Enclosure 5
NRC Whitepapers
Meeting Summary of the 12/10/08 Reactor Oversight
Process Working Group Public Meeting
Dated December 30, 2008

Staff White Paper on NEI 99-02 Guidance Changes for MSPI for Clarification of
Planned UA Expectations

Staff White Paper for Long-term MSPI Baseline Unavailability Options

Staff White Paper
EDG Component Boundary

Figure 1
MSPI Scoping

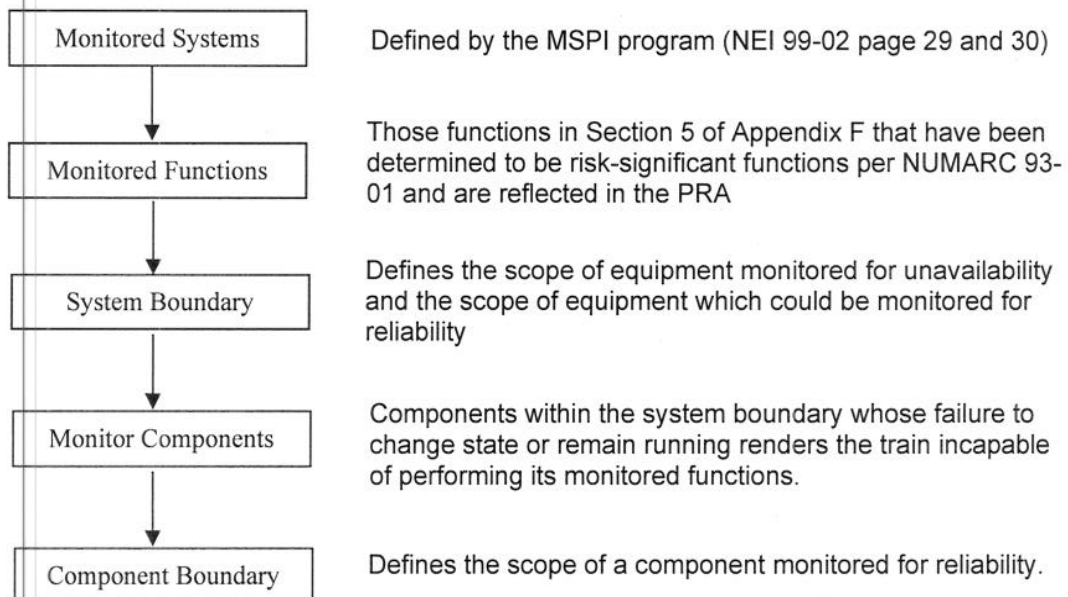
The treatment of the failures associated with the EDG fuel oil system is unclear as the fuel oil system is stated as being within the boundary of the EDG super component but the fuel oil transfer pumps (which are part of the fuel oil system) are stated as not being monitored.

The fuel oil system (including local or day tank) is identified as being part of the EDG super component (within the component boundary) while the fuel oil transfer pump is within the system boundary, but is not considered to be a monitored component. Its exclusion is stated as being due to the difficulty in obtaining accurate estimations of demands and run hours (due to the auto start and stop feature of the pump) and due to the expected small contribution to the index (NEI 99-02, Section F.5). Although Section F.5 states that the EDG Fuel Oil Transfer Pumps are exempt from unreliability monitoring, it implies that these pumps would normally have been monitored except for difficulties in data tabulation and in some cases for plants with multiple redundant pumps, their low risk significance. Additionally they are monitored for contribution to train unavailability only if an EDG train can only be supplied from a single transfer pump. Section F.5 notes that there are configuration differences where the capability may exist to supply an EDG from redundant transfer pumps which would result in the contribution to the EDG MSPI from these components to be small compared to the contribution from the EDG itself.

NEI 99-02 Section F 2.1.3 provides the basic philosophy stating that a support component that solely supports the operation of the monitored component should be considered part of the component boundary. If a support component supports multiple components, it should not be considered as part of the monitored component. Although this section refers to relays, breakers or contactors, it could be applied to the relationship between the fuel transfer pumps and the diesels.

The staff proposes to align the fuel oil system issue with the philosophy of Section F 2.1.3 which states that a support component that solely support the operation of the monitored component should be considered part of the component boundary. Therefore, if a portion of the fuel system (including the fuel oil transfer pumps) that uniquely supports a single EDG results in the failure of the EDG, then that failure will be considered to be within the EDG component boundary and will be recorded as a failure against the EDG. This approach allows flexibility in the definition of the fuel oil system boundary such that the various plant configurations can be accommodated. If the failure of the failure of the fuel oil transfer pump results in a depleted day tank and the inability of the EDG to perform its mission (assume tank depletion occurs during an actual demand), then this event would be an EDG failure. If the failure of the fuel oil transfer pump does not result in an EDG failure, then no EDG failure would be recorded.
